# 2ND AND VIRGINIA

ITEM	BOARD GUIDANCE	RESPONSE
<b>1. Massing and Design Concept</b>	<p>The Board was supportive of the applicant's preferred massing alternative, Option C, as this option seemed to offer the most relief to the historic structure by setting back from the existing landmark building, the Terminal Sales Annex, on site and provided the strongest design concept (stepping massing) which created an interesting concept and means to breaking down the height, bulk, and scale of the proposed tower. Further the Board supported the location of the tower on site as the proposed tower siting provided setback from the Viktoria Tower to the south.</p>	<p><b>SUPPORTED BY EDG</b></p> <ul style="list-style-type: none"><li>• <b>The design team has incorporated the preferred design direction from the Board as the tower has evolved.</b></li></ul> <p><i>Thee following design guidelines will be better supported: A1 Respond to the Physical Environment, B3 Reinforce the Positive Urban Form &amp; Architectural Attributes of the Immediate Area.</i></p>

# RESPONSE TO BOARD GUIDANCE

Departure 2

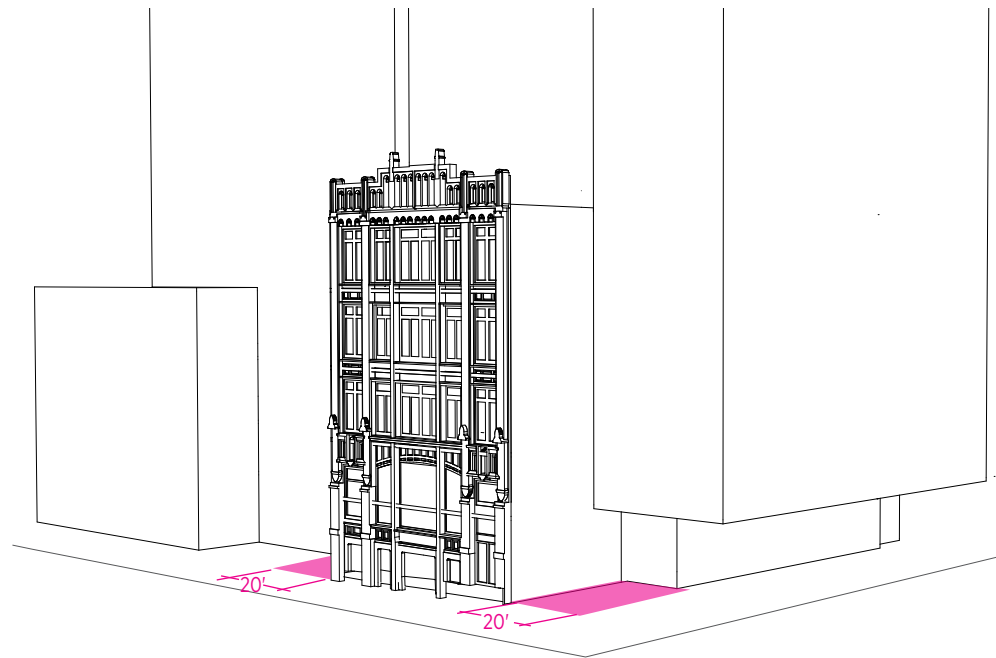
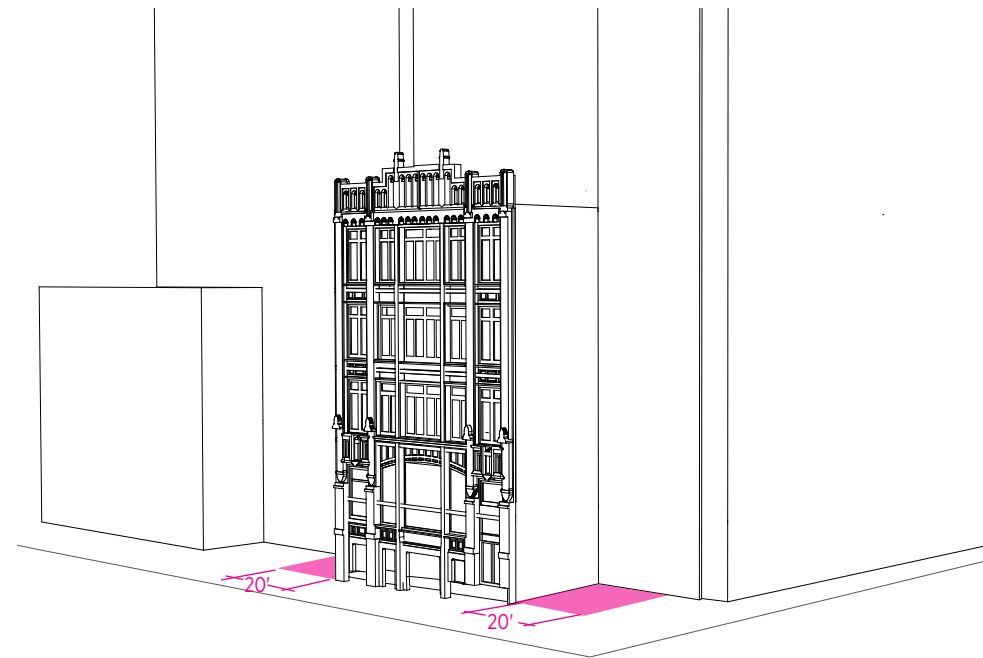
A departure is requested to increase width of setback to relate to the TSA on the south, while opening the corner to Landmark on the North. We are requesting 43' on the south and 30' on the north.

South of the TSA: The width of the setback on the south of TSA is directly related to the width of the TSA itself. The TSA is approximately 45' wide and the width of the setback is approximately 48'. This width also is directly related to the proportions of the tower's telescoping form concept.

North of the TSA: To create a corner open space and for the Landmark to 'front' the corner, a greater setback is required. This corner open area reveals the lower edge of the tower as it descends from above, hovering just above ground at the main entry.

## Departure 3

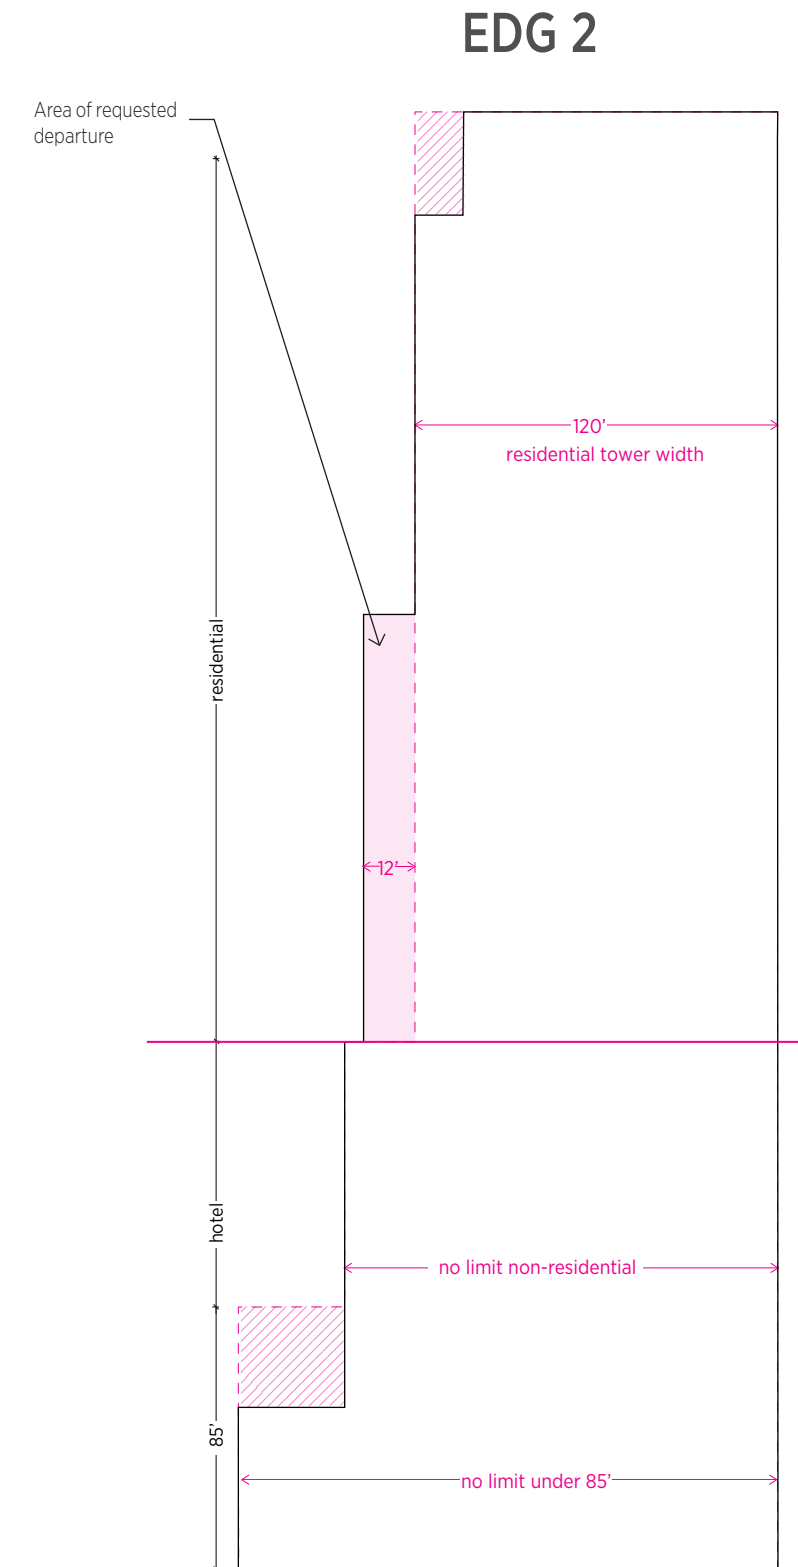
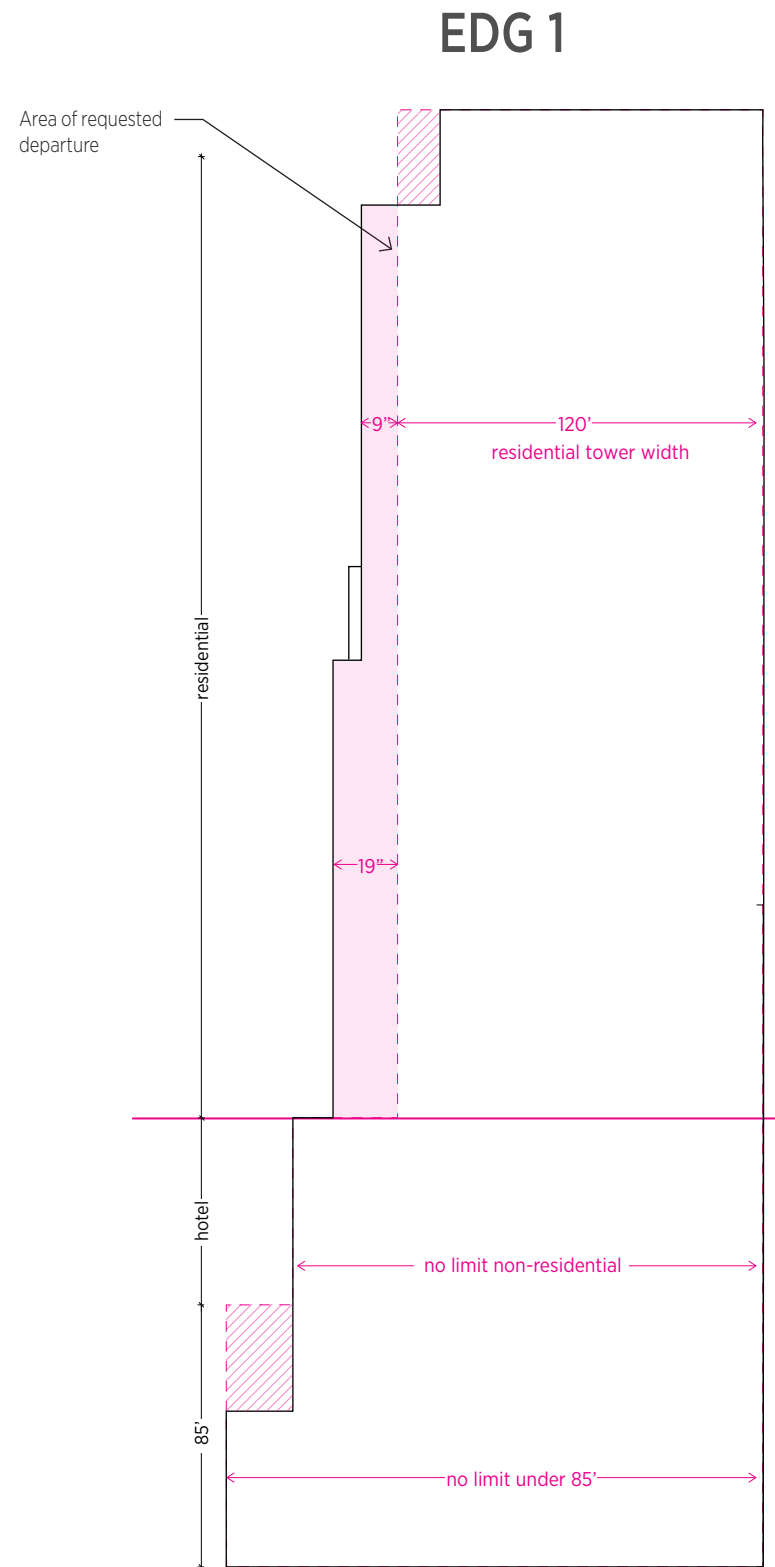
A departure is requested to extend the residential portion of the tower by 12' at the widest section.

The current maximum facade width is not ideal for the historic landmark on site. When the tower sets back from the landmark, it immediately creates a more rectangular tower which does not allow an average tower plate of 10,700sf without increasing the overall width. By setting the entire tower back from the landmark by 18', it essentially widens the tower to create an average residential footprint of 10,500sf.

At EDG 1, the project team had requested 19' of additional width at Levels 14-27, and additional 9' at Levels 28-41. At EDG 2, the project team has significantly reduced the tower width to better meet the tower width requirement. The project now meets the tower width requirement at the top portion of the tower, and a departure is only requested at the middle section of the tower. The Architectural Review Committee is supportive of this departure.
